Riley Purgatory Bluff Creek Watershed District Permit Application Review

Permit No: 2021-085

Project: 7851 Park Drive Storage Expansion: Proposed addition of an approximately 8,100 SF outdoor gravel storage area and a one-way concrete drive entrance. Proposed stormwater feature includes an iron-enhanced filtration basin with elevated underdrain to promote infiltration to provide stormwater rate, volume, and quality control.

PLANTING SCHEDULE

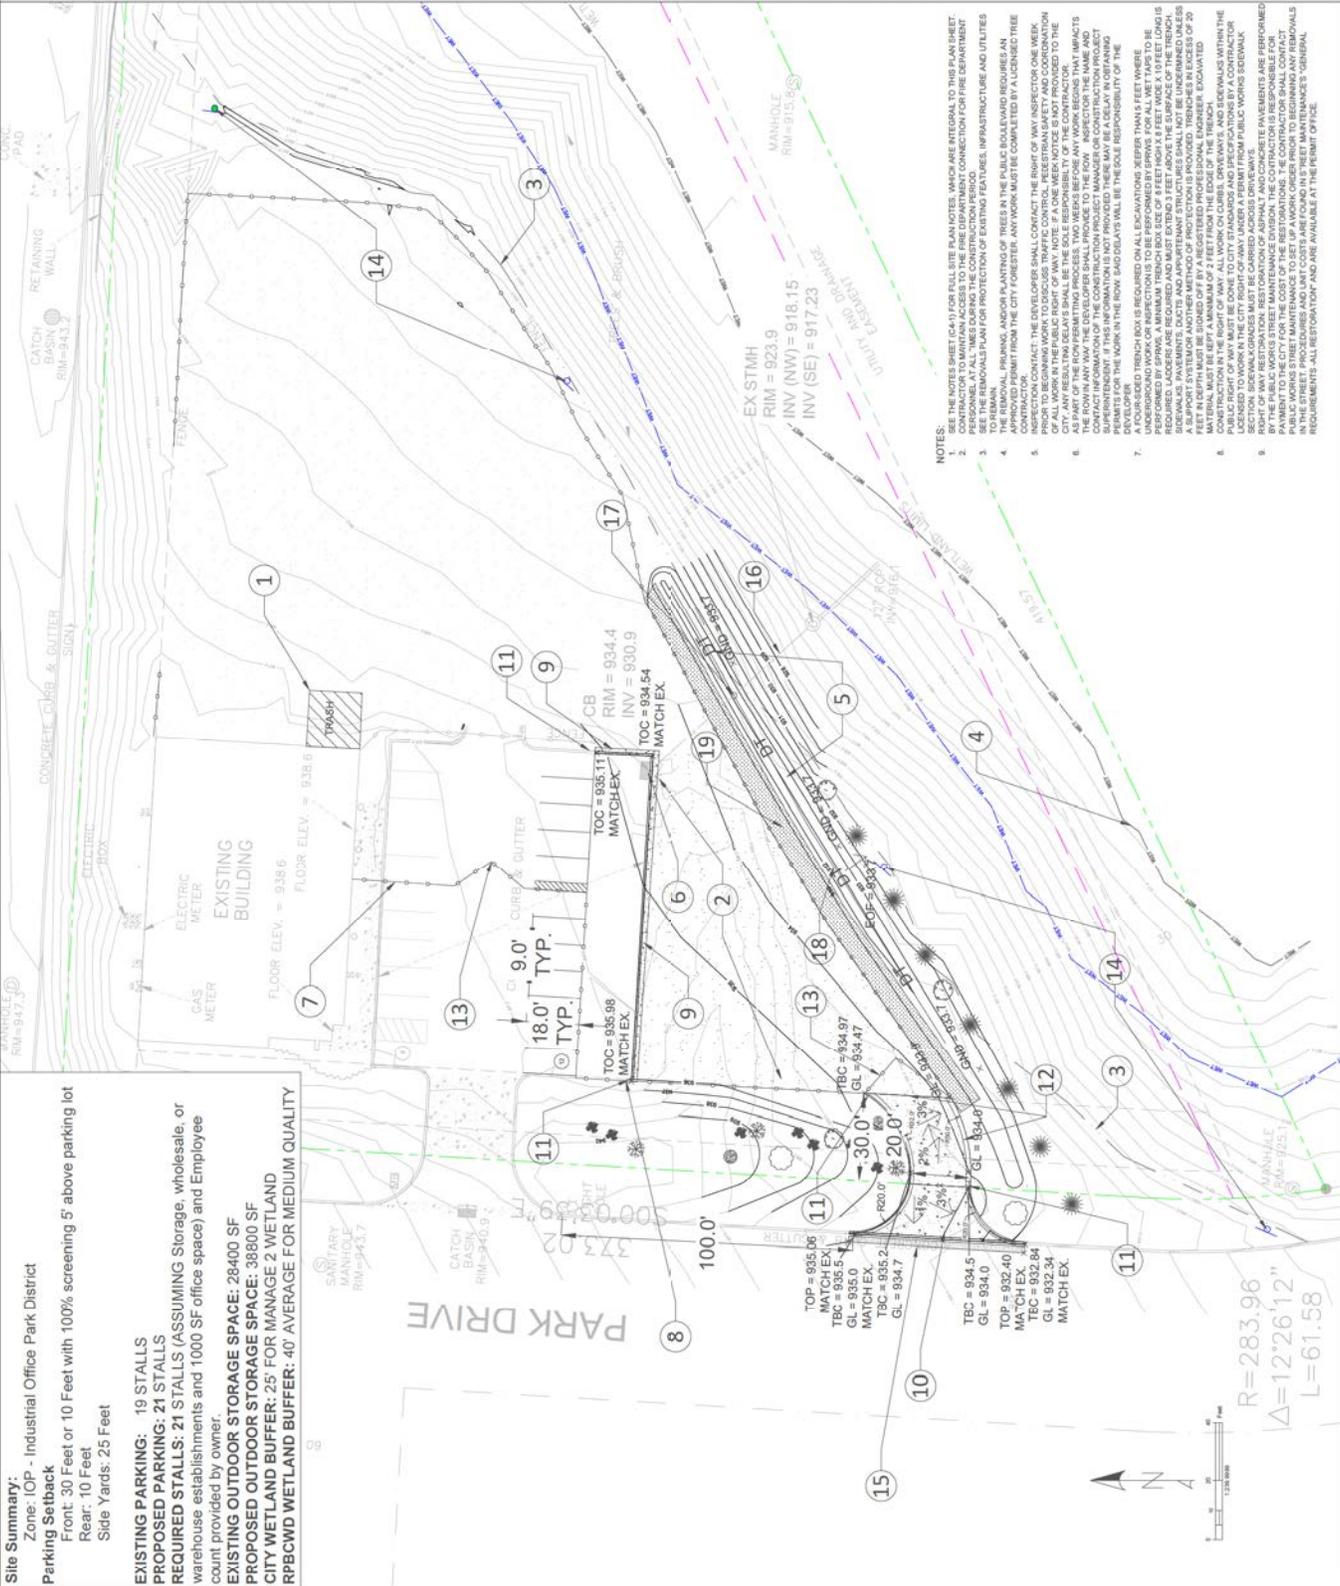
- D1. The Landscape Plan (C3-1) must be updated to indicate all disturbed areas within the buffer will be revegetated using a native seed mix conforming to Rule D, Subsection 3.3.
- D2. Buffer marker sign must be updated with text in material conformity with a design and text provided by the District. A sample buffer sign is available on RPBCWD permitting webpage (https://rpbcwd.org/download_file/view/28/174)
- D3. Buffer areas and maintenance requirements must be documented in a declaration recorded after review and approval by RPBCWD in accordance with Rule D, Subsection 3.5.

1. Financial Assurance in the amount of \$30,834.
2. Receipt of an update Landscape Plan (C3-1) to indicate all disturbed areas within the buffer will be revegetated using a native seed mix conforming to Rule D, Subsection 3.3.
3. Receipt of updated plans showing the buffer marker sign with text in material conformity with a design and text provided by the District. A sample buffer sign is available on RPBCWD permitting webpage (https://rpbcwd.org/download_file/view/28/174)
4. Receipt in recordation a maintenance declaration for the stormwater management facilities and buffers. Drafts of any and all documents to be recorded must be approved by the District prior to recordation. Permit applicant must provide a proof of recordation as a condition of issuance of the permit.
